PADUCAH FEDERAL FACILITY AGREEMENT—SIGNED MEMORANDUM OF AGREEMENT FOR RESOLUTION OF DISPUTE FOR THE FEASIBILITY STUDY FOR SOLID WASTE MANAGEMENT UNITS 2, 3, 7 AND 30 OF THE BURIAL GROUNDS OPERABLE UNIT AT THE PADUCAH GASEOUS DIFFUSION PLANT, PADUCAH, KENTUCKY (DOE/LX/07-1274&D2)

MEMORANDUM OF AGREEMENT FOR RESOLUTION OF DISPUTE

*Feasibility Study for Solid Waste Management Units 2, 3, 7, and 30
of the Burial Grounds Operable Unit
at the Paducah Gaseous Diffusion Plant, Paducah, Kentucky
(DOE/LX/07-1274&D2)*

Memorandum of Agreement Table
Summarizing Resolutions to EPA and KDWM Disputed Conditions for the
*Feasibility Study for Solid Waste Management Units 2, 3, 7, and 30 for the Burial Grounds Operable Unit at the
Paducah Gaseous Diffusion Plant, Paducah, Kentucky (DOE/LX/07-1274&D2)*

Figure 6.XX Identified Uncertainties with SWMU 3, Alternative 3

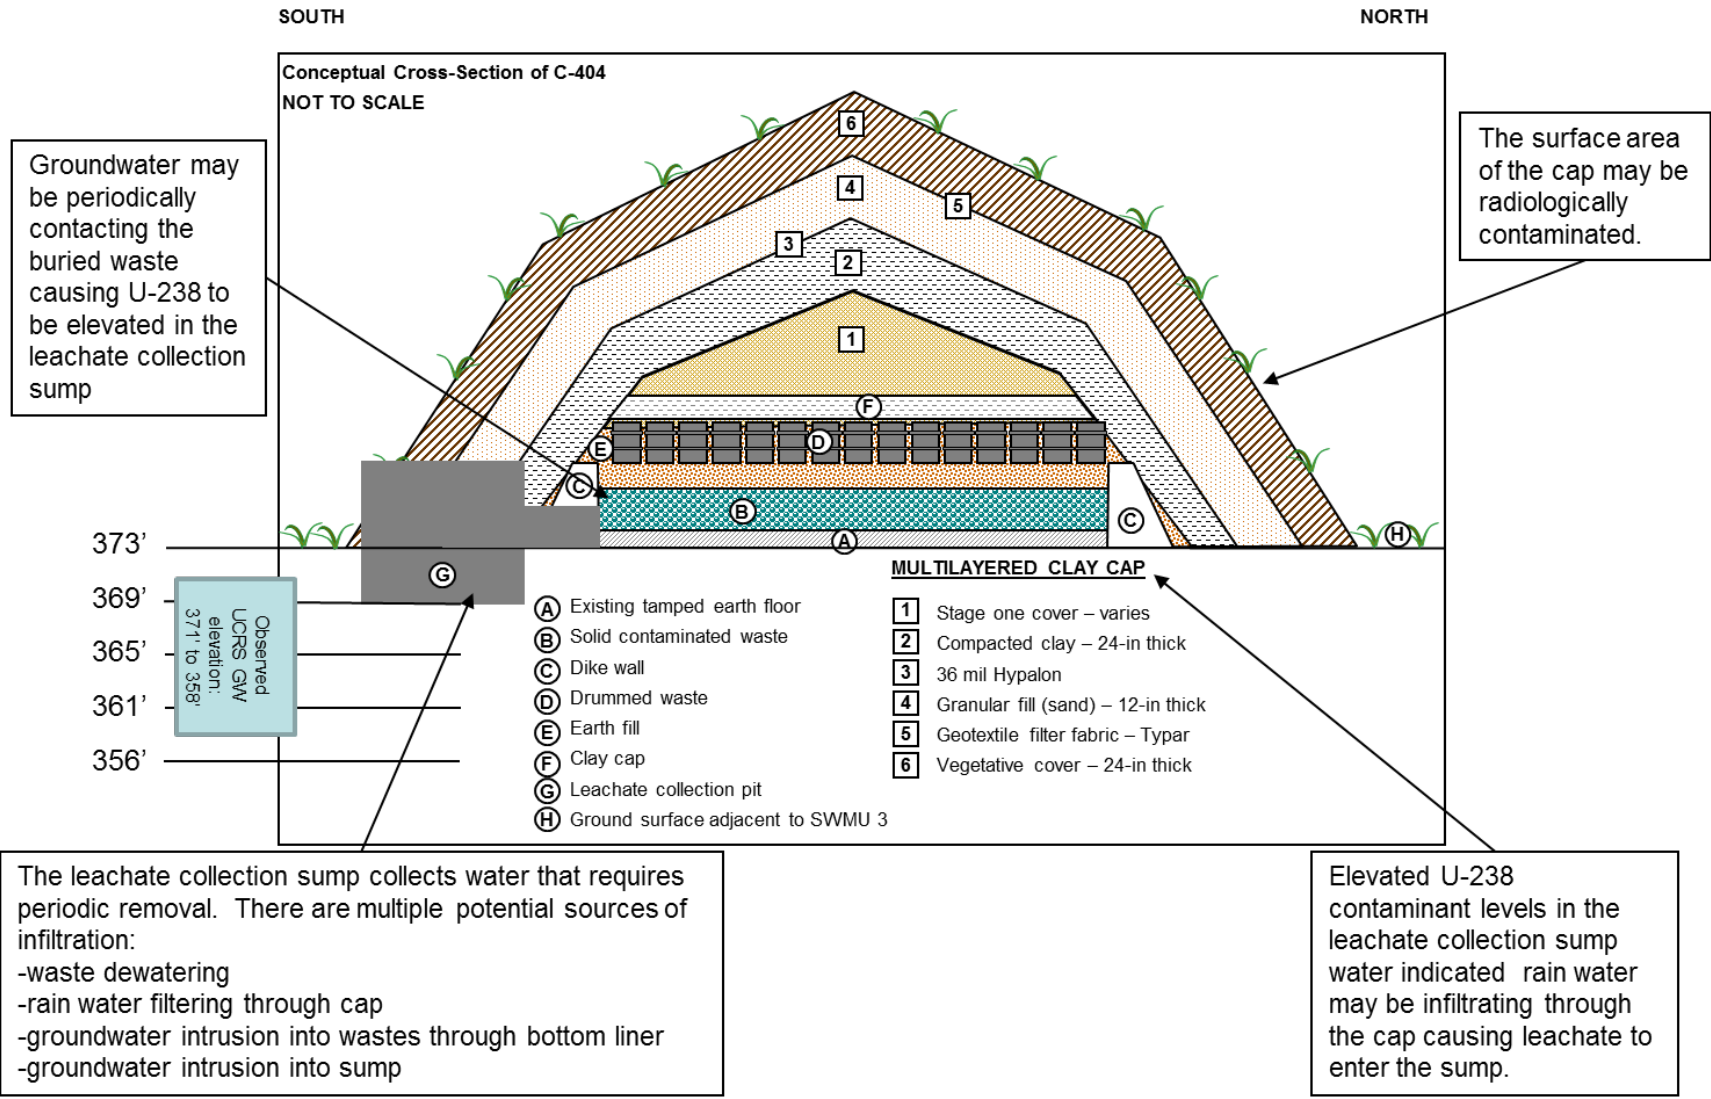
Uncertainties. As previously stated, there are uncertainties associated with (1) possible radiological contamination of the surface soil on/in the existing RCRA Subtitle C cap, (2) the integrity of the existing Subtitle C cap, (3) the integrity of the clay bottom liner (i.e., the well-tamped clay floor that served as the floor of the former surface impoundment), and (4) the integrity of the concrete leachate collection sump/pit (see Section 1.5.7, Table 1.13, Section 1.6.3.1, and Section 1.6.3.2). Figure 6.XX illustrates these uncertainties.

As part of the RDSI, an Engineering Evaluation will be conducted to evaluate impacts of the riprap on the integrity and performance of the existing RCRA Subtitle C cap. The Engineering Evaluation also will consider the RDSI data to determine if additional measures need to be implemented to address any/all of the uncertainties. Additional measures to address the uncertainties may include additional cover over the existing cap to address radiological contamination, additional liners over the existing cap to prevent rain water infiltration, slurry walls to prevent groundwater intrusion through the clay bottom liner, and/or lining or replacement of the sump/pit to prevent leakage.

If it is determined that the SWMU 3 cap is radiologically contaminated and has caused surficial/shallow radiological contamination beyond the SWMU 3 administrative boundary, then this contamination will be addressed by Alternative 3.
